March 21, 1994  
ML-94-012

Subject: **Hematite License Renewal - Radiological Changes**

COMBUSTION ENGINEERING, INC.  
HEMATITE NUCLEAR FUEL MANUFACTURING FACILITY  
LICENSE RENEWAL APPLICATION  
RADIOLOGICAL CHANGES  
DESCRIPTION OF CHANGES

Figure 11-1  
 Hematite Plant Organization Chart

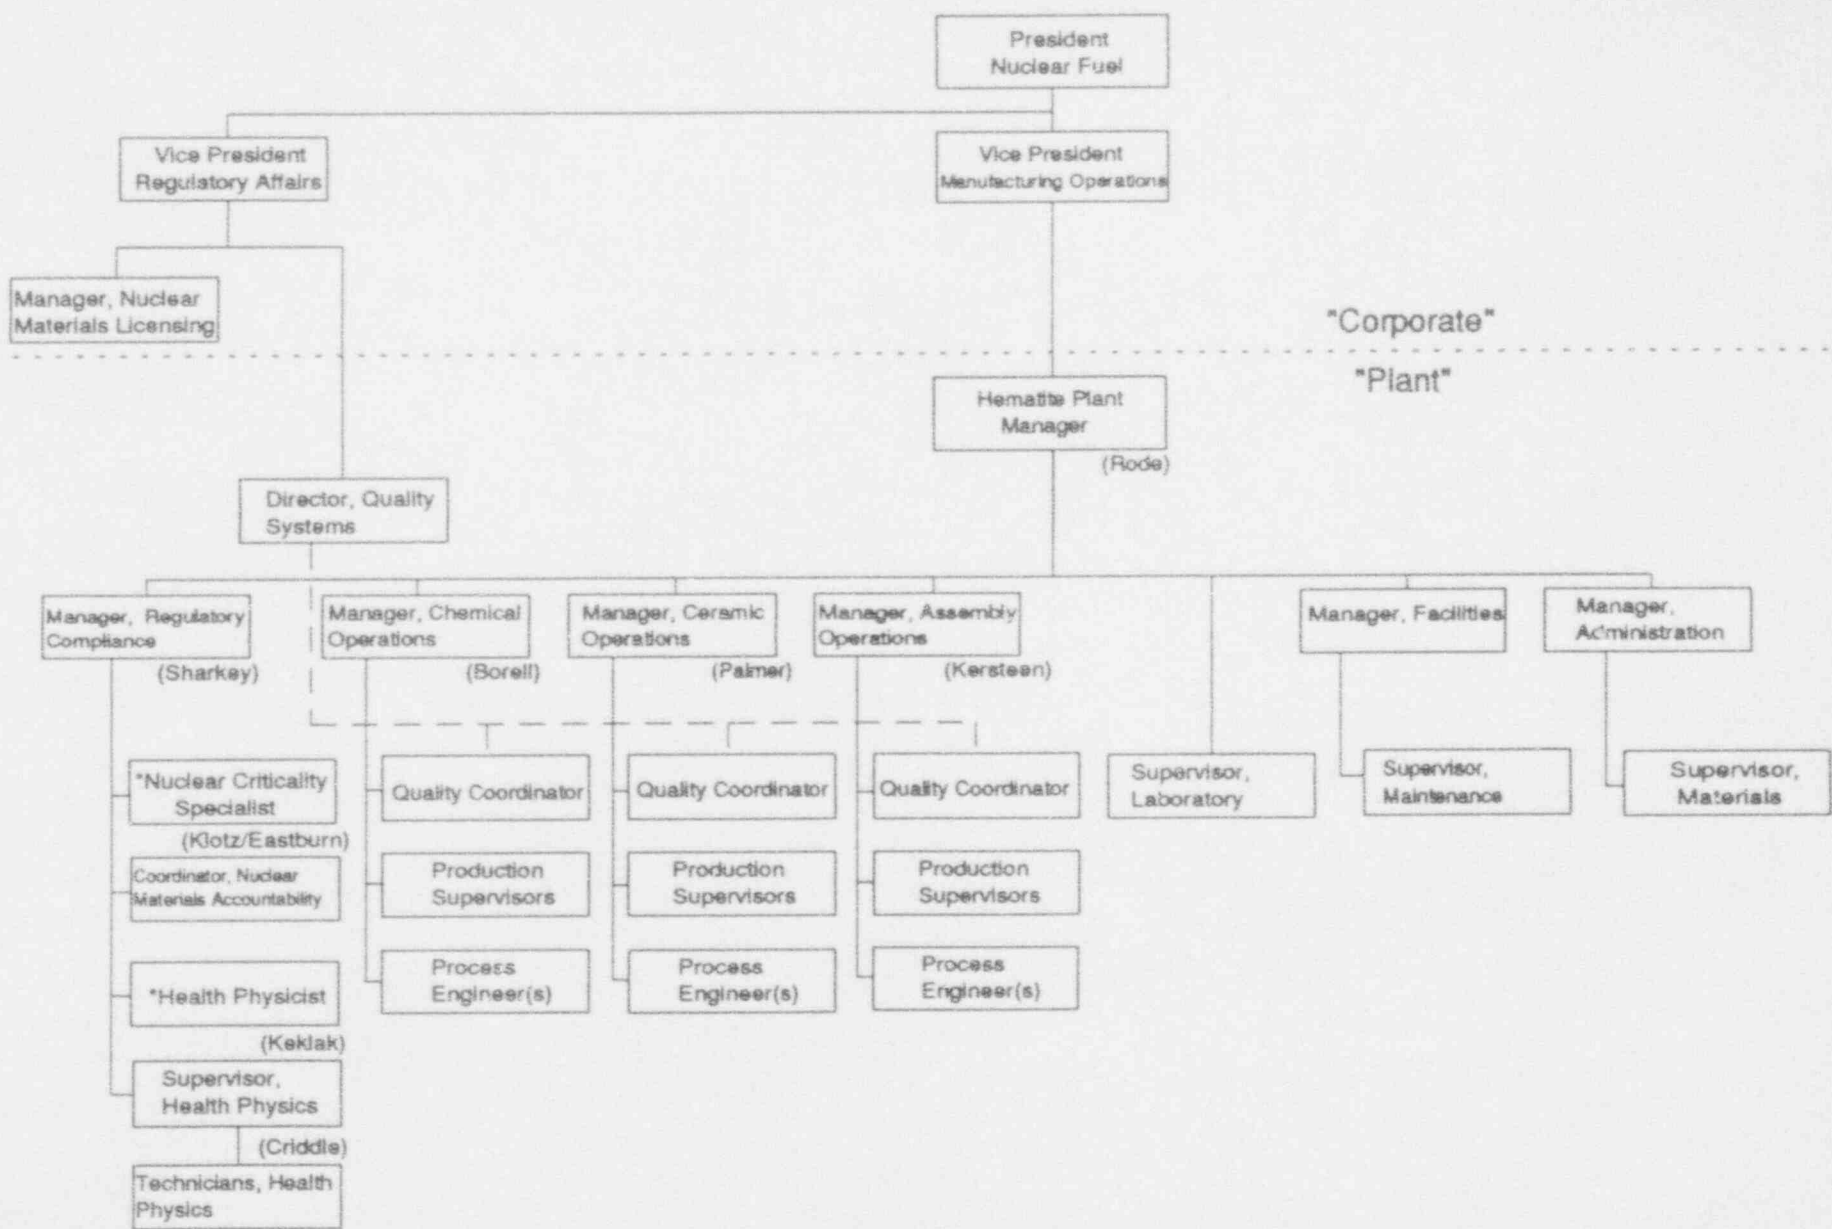
In Part II, Chapter 11 has been changed to describe the functions of the process engineers (new Section 11.1.3; succeeding sections renumbered). The process engineering function is shown on the revised organization chart of Figure 11-1.

Figure 12-1  
Contamination Control Areas and Control Points

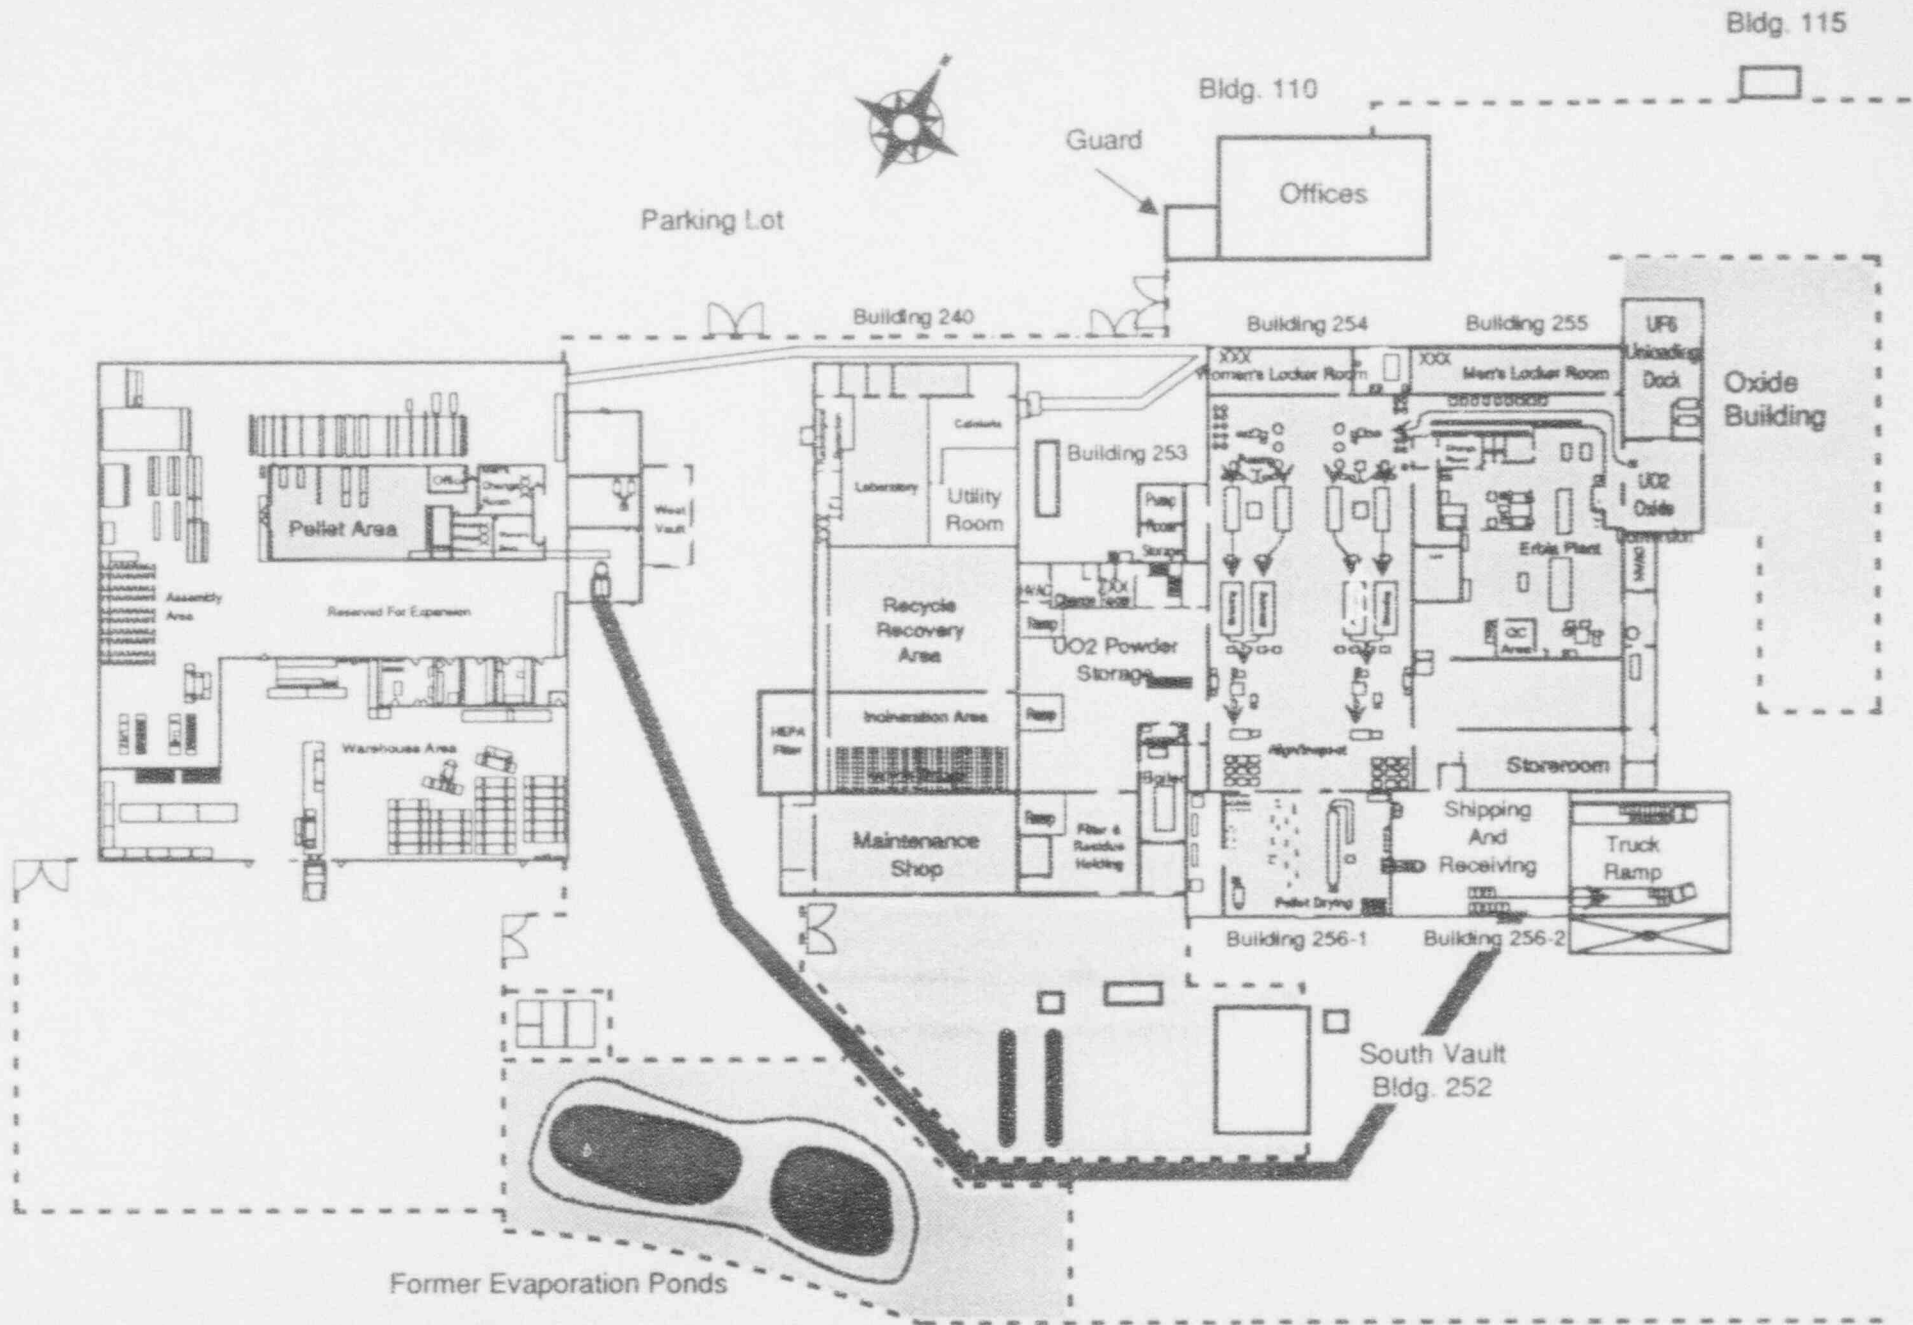
Figure 12-1 has been revised to depict the contamination control areas of the entire plant site and terminology has been changed from "restricted area" to "contamination control area". Former Figure 12-2 has been deleted and the text in former Section 12.4 (new Section 12.6) has been changed accordingly. The text of former Section 12.14 has been moved to this section, and former Section 12.14 has been eliminated.
